Access Compliance Report

Public Rights-of-Way

(Curb Ramps)

Intersection ID: 27803	Main Street: JAMES JACK LN	Cross Street: RESOLVES LN	Location:	N
ADA ID: 6F0C9F5E70D6	Ramp Type: PerpDiag	Initial Pass/Fail: Fail	Overall Compliance: No	Severity Score: 21.25
Codes/Mitigation Info/Possible Solution		Field Measurements/Component Compliance

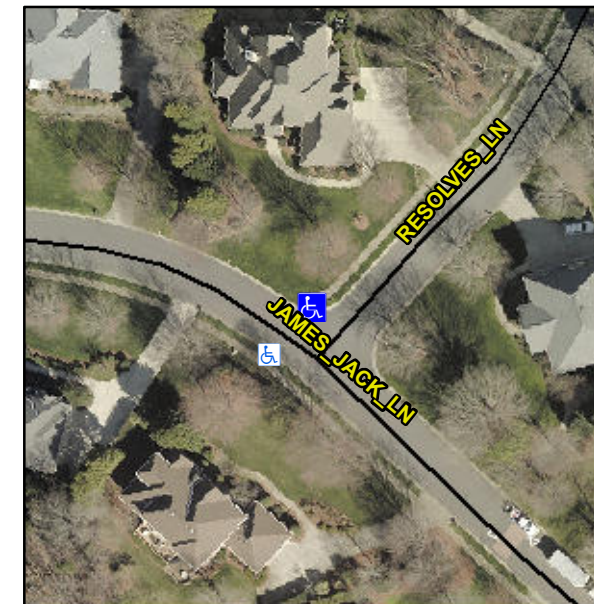
Not Found, R304.5.1, R304.5.3

Compliance	Description	Data	Compliance	Description	Data
N/A	Ramp Length (in)	52.0	Yes	Ramp Slope (%)	5.1
No	Ramp Width (in)	42.0	No	Ramp XSlope (%)	5.8
N/A	Flare Type LT	N/A	N/A	Flare Type RT	N/A
N/A	Flare Slope LT (%)	N/A	N/A	Flare Slope RT (%)	N/A
N/A	Flare Traversable LT?	N/A	N/A	Flare Traversable RT?	N/A
N/A	Landing Length (in)	N/A	N/A	DWS Provided?	N/A
N/A	Landing Width (in)	N/A	N/A	DWS Contrast?	N/A
N/A	Landing Slope (%)	N/A	N/A	DWS Length (in)	N/A
N/A	Landing X Slope (%)	N/A	N/A	DWS Full Width?	N/A
N/A	Landing Curb? (Y/N)	N/A	N/A	DWS Offset (in)	N/A
N/A	Shared Landing?	N/A			
N/A	Gutter Ponding?	N/A	N/A	Gutter Slope (%)	N/A
N/A	Gutter Lip Ht (in)	N/A	N/A	Gutter X Slope (%)	N/A
N/A	Painted X Walk1?	No	N/A	Painted X Walk2?	No
	X Walk 1 Direction	To SW		X Walk 2 Direction	To SE
N/A	X Walk 1 Width (in)	N/A	N/A	X Walk 2 Width (in)	N/A
	X Walk 1 Slope (%)	6.9		X Walk 2 Slope (%)	6.7
	X Walk 1 X Slope (%)	6.1		X Walk 2 X Slope (%)	0.9

Remove & Replace Curb Ramp With Two New Directional Ramps or Equivalent.
